### Draft Regulation

Building Act  
(chapter B-1.1)

#### **Construction Code — Chapter I.1, Energy Efficiency of Buildings — Amendment**

## Regulation to amend the Construction Code

**Figure A-1.1.2.1.  
Decision flow chart for Code compliance”;**

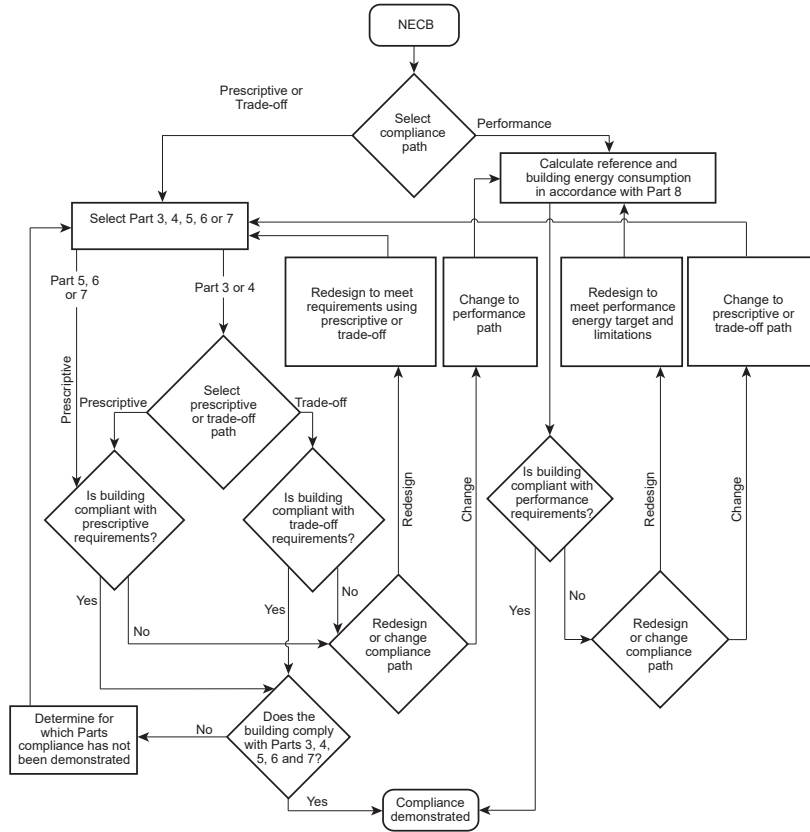
Replace Figure A-1.1.2.1. by the following:

**Figure A-3.1.1.6.(6)**  
**Calculation of the Area of Opaque Building Assemblies”.**

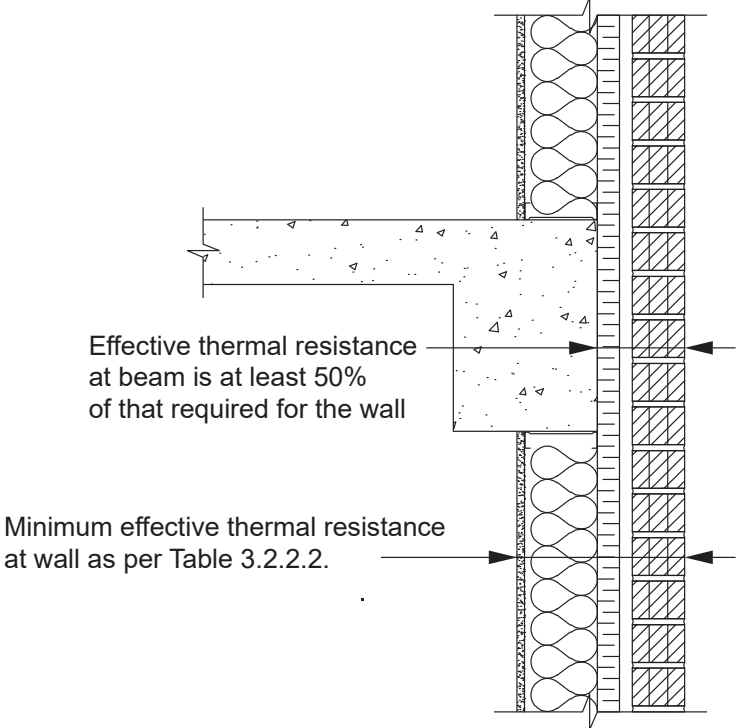
<b>A-3.1.1.6.(1)</b>	<p>Insert the following Sentences after the first Sentence of the Note:</p> <p>“Garage doors are included in the calculation of the door and fenestration area of a building.</p> <p>The opaque sections (spandrel panels) of curtain walls are part of the opaque building assembly. That component of curtain walls shall be taken into account in the calculation of the area of opaque building assemblies and not in the calculation of the fenestration and door area.”.</p>
	<p>Add the following Note:</p> <p><b>“A-3.1.1.6.(6) Calculation of the Area of Opaque Building Assemblies.</b> Parapets, projected fins, ornamentation, appendages, and fenestration and doors, are excluded from the area of opaque building assemblies. The area of an opaque building assembly in contact with the ground shall be calculated from the exterior ground level to the bottom surface of the slab-on-ground.</p>

Figure A-3.1.1.6.(6) illustrates the calculation of the area of opaque building assemblies according to the requirements of Sentence 3.1.1.6.(6).

**Figure A-3.2.1.2.(3)-D**

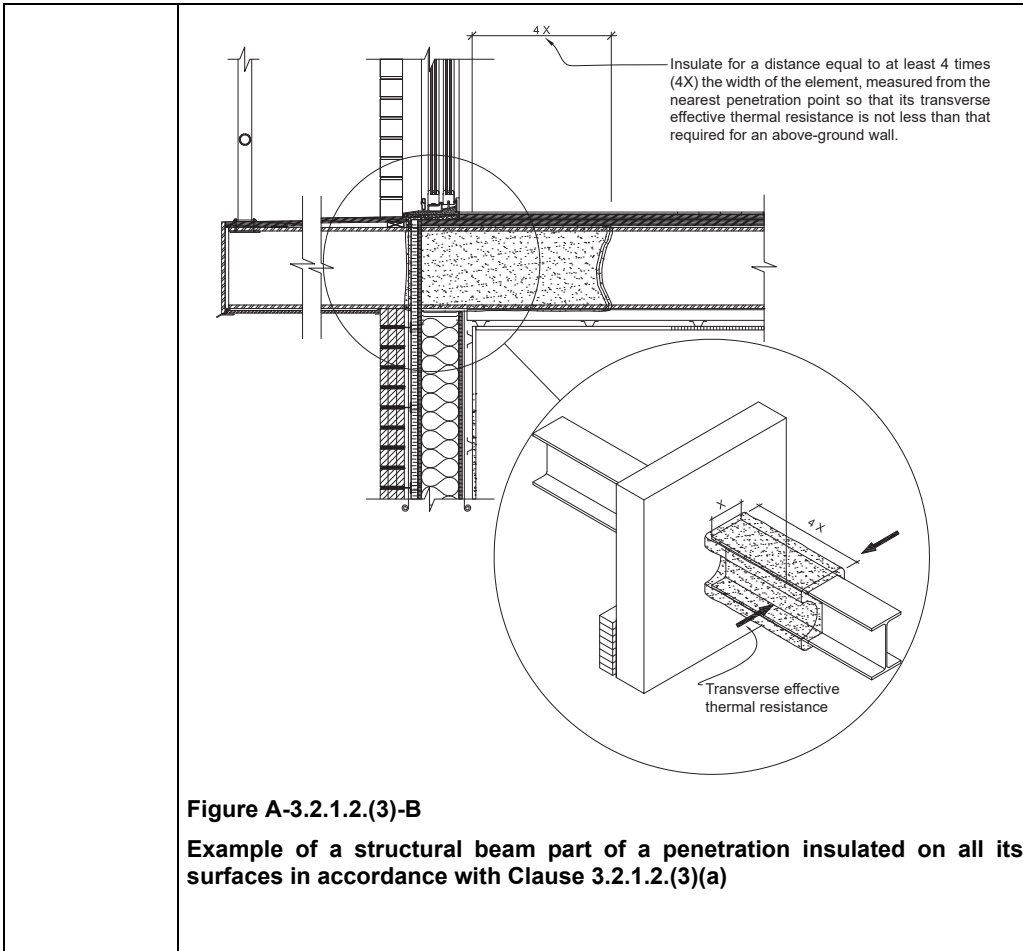
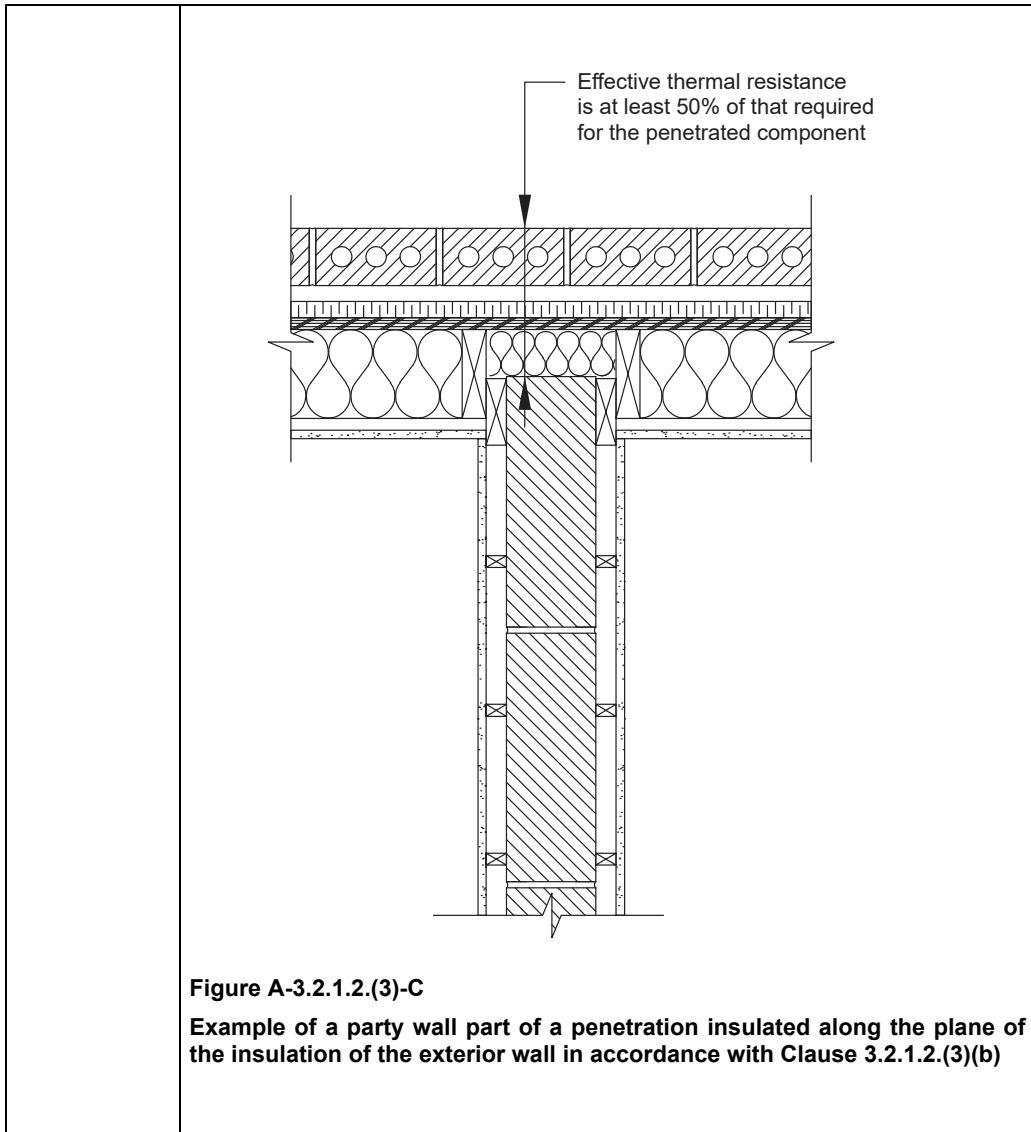
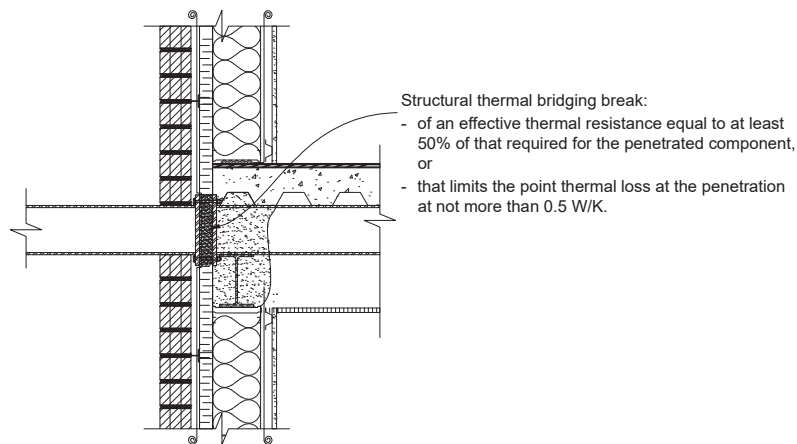
<p><b>A-3.2.1.2.(2)</b></p>	<p>Replace the Note by the following:</p> <p><b>“A-3.2.1.2.(2) Structural Members and Minor Penetrations.</b> Sentence 3.2.1.2.(2) takes into account the fact that repetitive structural members are already included in the method for calculating effective thermal resistance of building assemblies as described in Article 3.1.1.7.</p>
	<p>Add the following Notes:</p> <p><b>“A-3.2.1.2.(3) Break in the Continuity of Insulation.</b> Where they penetrate the envelope, interior walls, foundation walls, firewalls, party walls, structural members such as slabs, ornamentations and other appendages are an important source of heat losses and have a significant impact on the overall thermal performance of the building envelope.</p> <p>Figures A-3.2.1.2.(3)-A, A-3.2.1.2.(3)-B, A-3.2.1.2.(3)-C and A-3.2.1.2.(3)-D illustrate ways to comply with the requirements of Sentence 3.2.1.2.(3).</p> <p>The effective thermal resistance of the assembly is at least that required for an above-ground wall.</p> <p><b>Figure A-3.2.1.2.(3)-A</b></p> <p><b>Example of a firewall part of a penetration insulated on both of its sides in accordance with 3.2.1.2.(3)(a)</b></p>

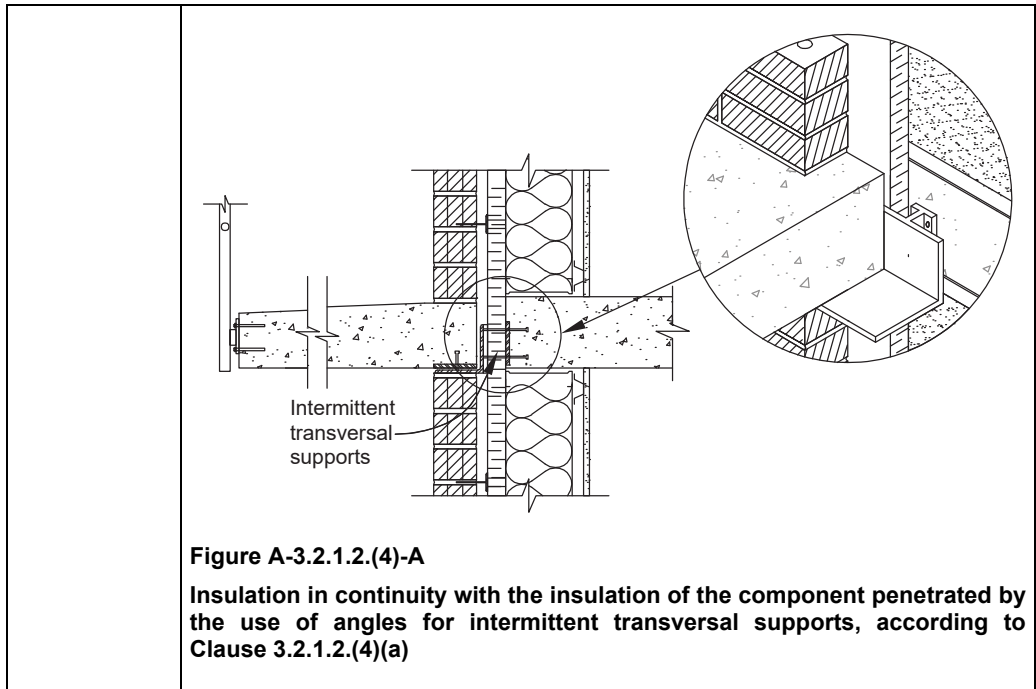
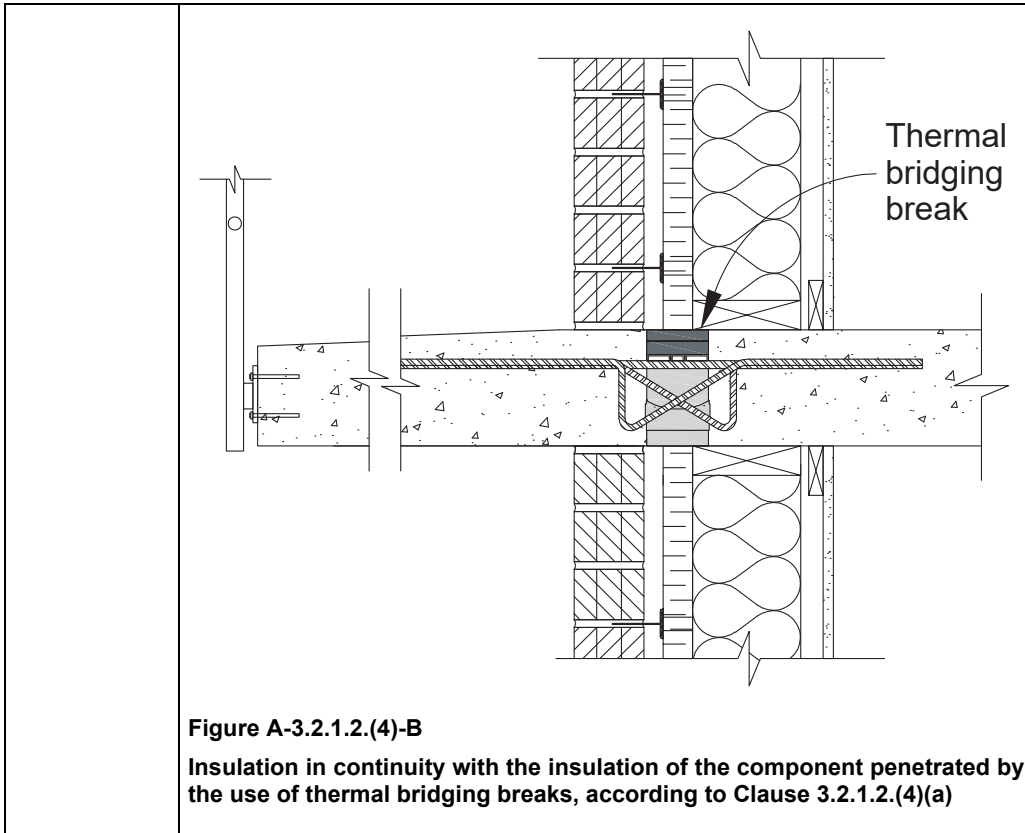
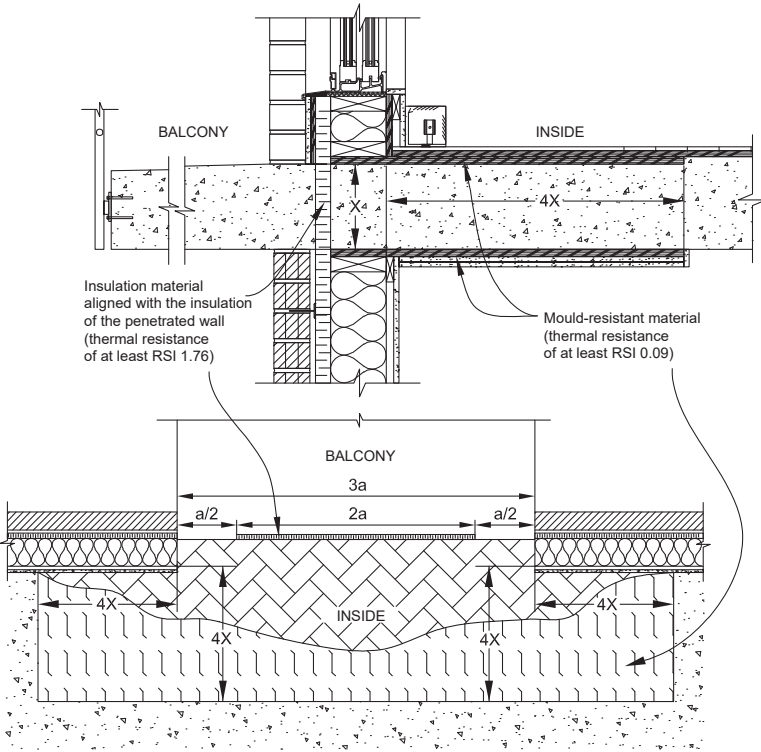
**A-3.2.1.2.(4) Insulation of a Concrete Slab.** Sentence 3.2.1.2.(4) is intended to limit heat loss at the level of concrete structural slabs that are often extended outward to become balconies. That heat loss results in an excessive energy consumption and may also be the source of discomfort for occupants. Figures A-3.2.1.2.(4)-A, A-3.2.1.2.(4)-B and A-3.2.1.2.(4)-C show ways to comply with the requirements of Sentence 3.2.1.2.(4).

The effective thermal resistance of the structural thermal bridging breaker excludes metal reinforcing members.

Where the assembly complies with the requirements of Clause 3.2.1.2.(4)(b), the insulation material under and above the slab should be mould resistant.

**Figure A-3.2.1.2.(5)**

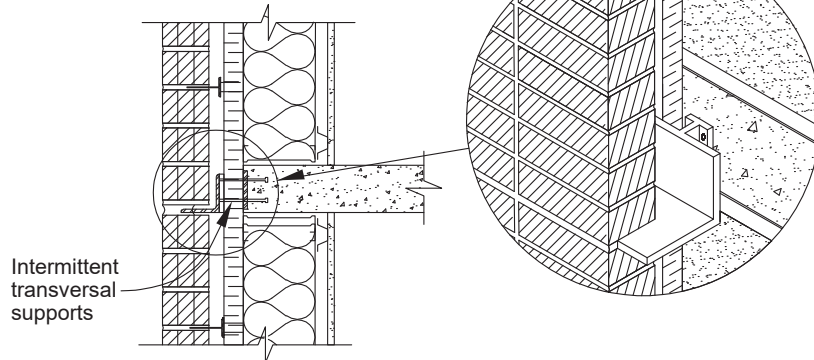
**Shelf angle attached to intermittent transversal supports**

**Figure A-3.2.1.2.(8)**

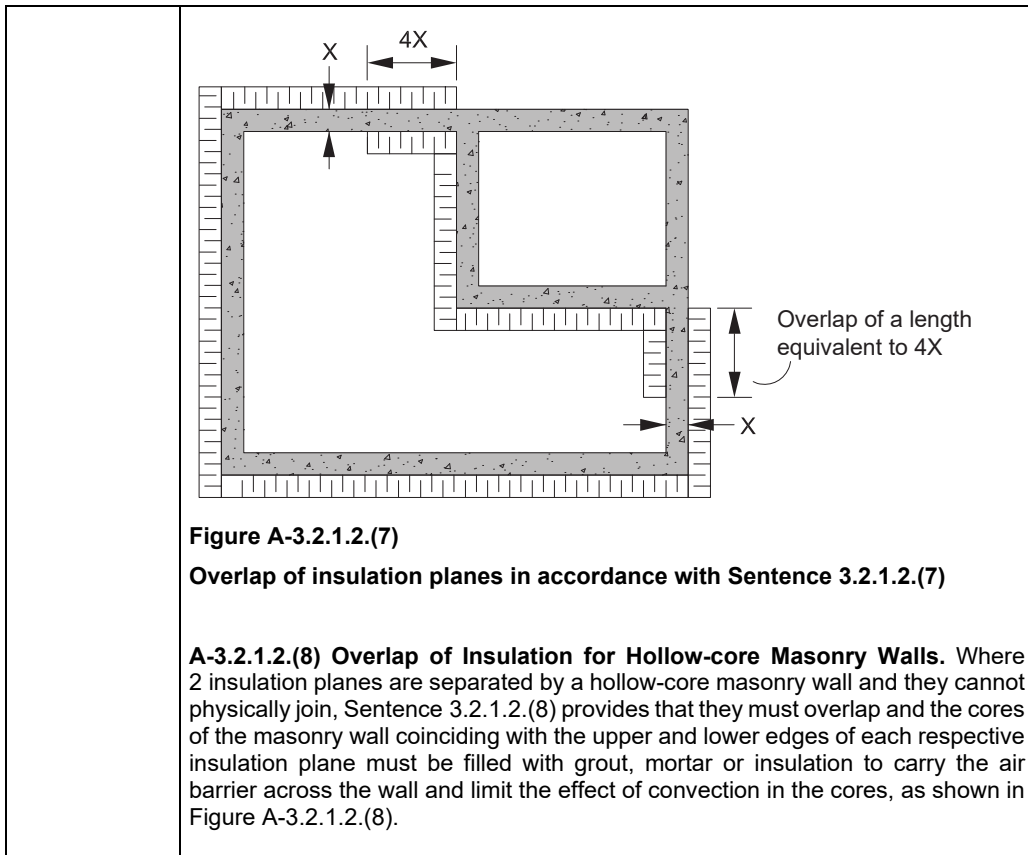
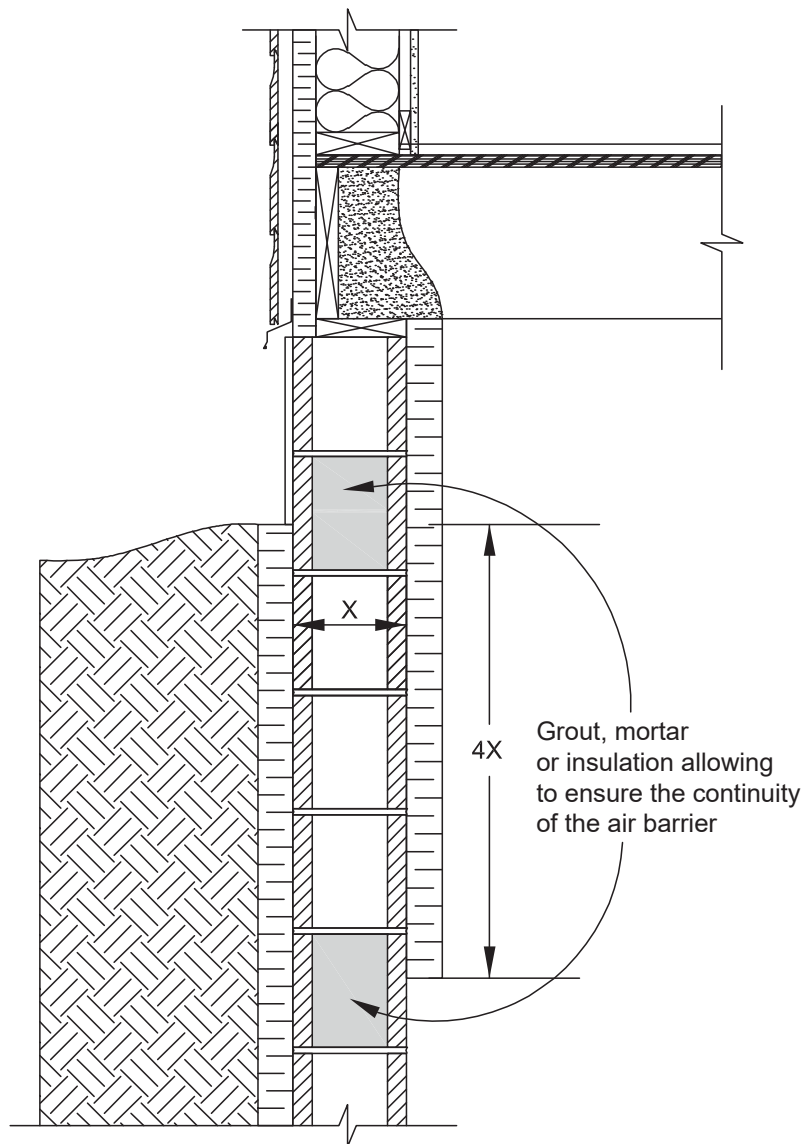
**A-3.2.1.2.(7) Insulation Overlap.** Where the break in insulation is due to the perpendicular interposition of a member of the envelope relative to another, Sentence 3.2.1.2.(7) requires that the overlap be carried out to extend the path of least thermal resistance from the inside out or toward an unconditioned adjacent space, as illustrated in Figure A-3.2.1.2.(7).

**Figure A-3.2.1.2.(9)(c)**

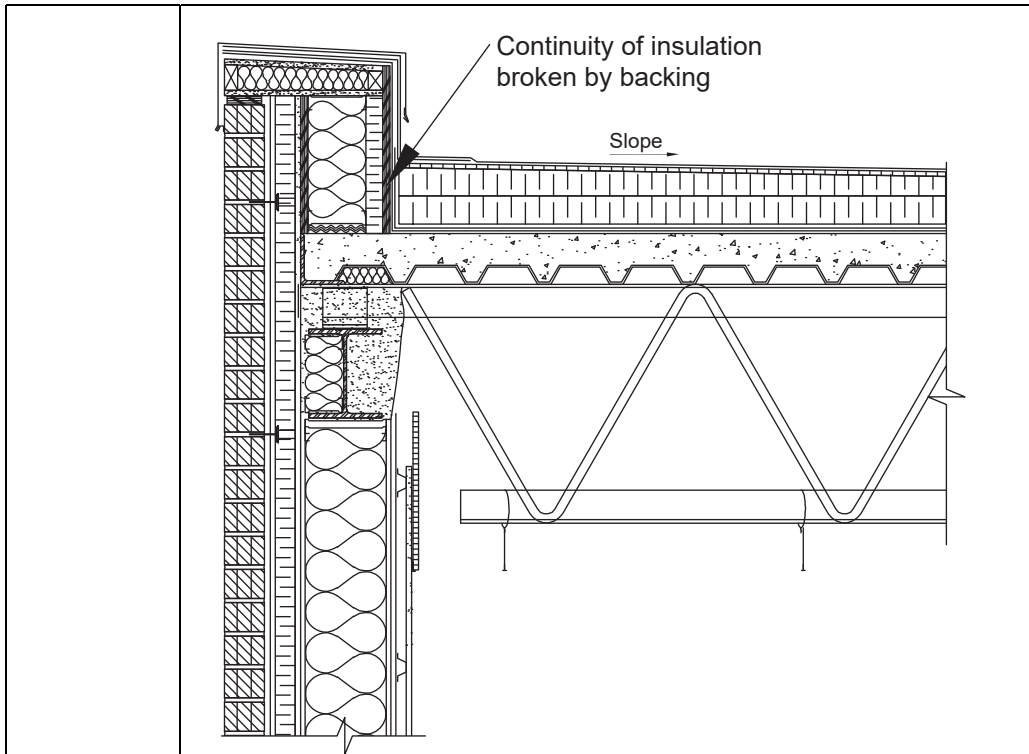
**A-3.2.1.2.(9)(c) Continuity of Insulation at the Level of Parapets.** The continuity of insulation may be broken at minor transitions between constructive systems, such as backing necessary to attach the membrane, tie rods and flashings. Figure A-3.2.1.2.(9)(c) shows an example where insulation is broken by backing.

**Figure A-3.2.2.2.(2) and (3)**  
**Insulation of a foundation wall having less than 50% of the surface exposed to outdoor air".**

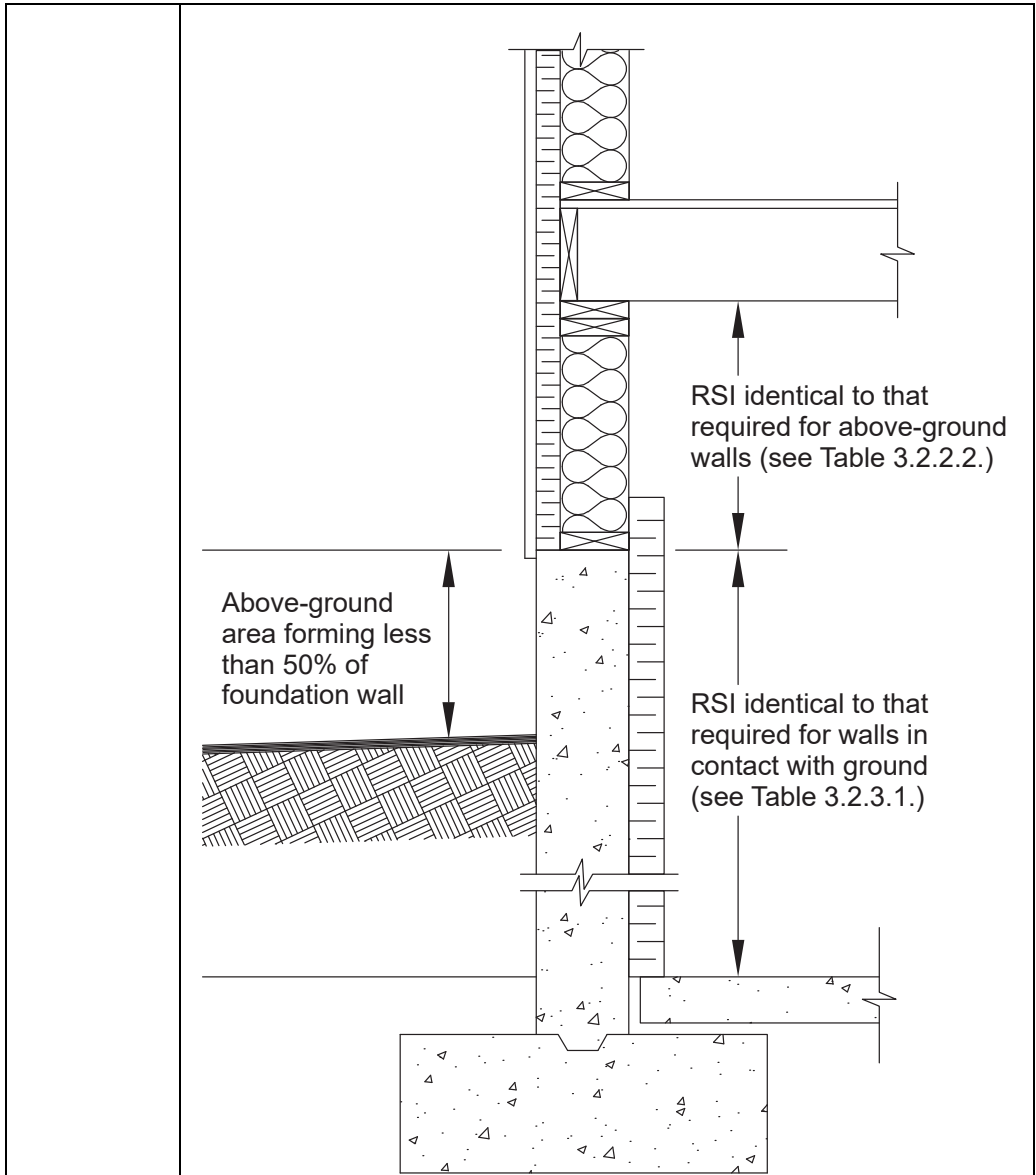
<b>A-Table 3.2.2.2.</b>	Strike out the Note.
	<p>Add the following Note:</p> <p><b>“A-3.2.2.2.(2) and (3) Insulation of an Exterior Wall.</b> The percentage of the exposed surface of the foundation walls must be established by considering each wall located in a same plane and for each storey. Where the foundation walls comprise various constructive systems, the percentage of the exposed surface is considered separately for each system. The entire above-ground surface of a foundation wall exposed to air over more than 50% of its surface will be insulated as an above-ground wall and the portion below ground level will be insulated as a wall in contact with the ground. Figure A-3.2.2.2.(2) and (3) shows an example of the application of Sentence (2).</p>
